Access Compliance Report

Public Rights-of-Way

(Curb Ramps)

| Intersection ID: 10140 | Main Street: E_36TH_ST | Cross Street: N_ALEXANDER_ST | Location: W |

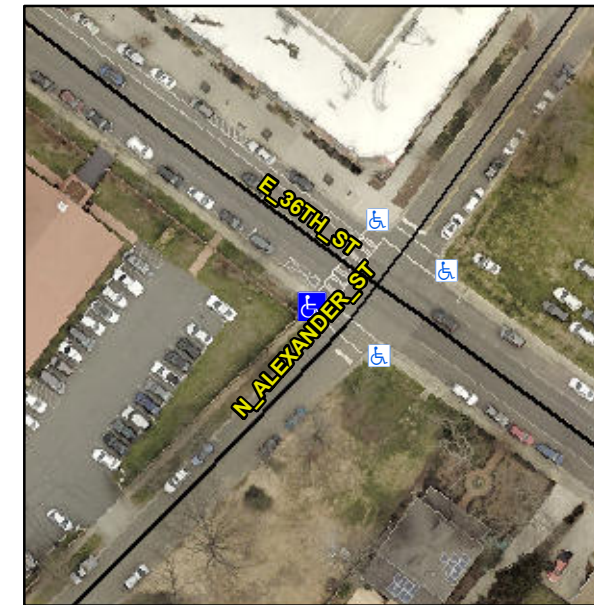
| ADA ID: C8793A7F9CB8 | Ramp Type: PerpDiag | Initial Pass/Fail: Fail | Overall Compliance: No |

Not Found, R304.5.3

| Compliance | Description | Data | Compliance | Description | Data |
|------------|-----------------------|-------|------------|-----------------------------|-------|
| Yes | Ramp Width (in) | 48.0 | No | Ramp XSlope (%) | 2.3 |

Remove & Replace Curb Ramp With Two New Directional Ramps or Equivalent.
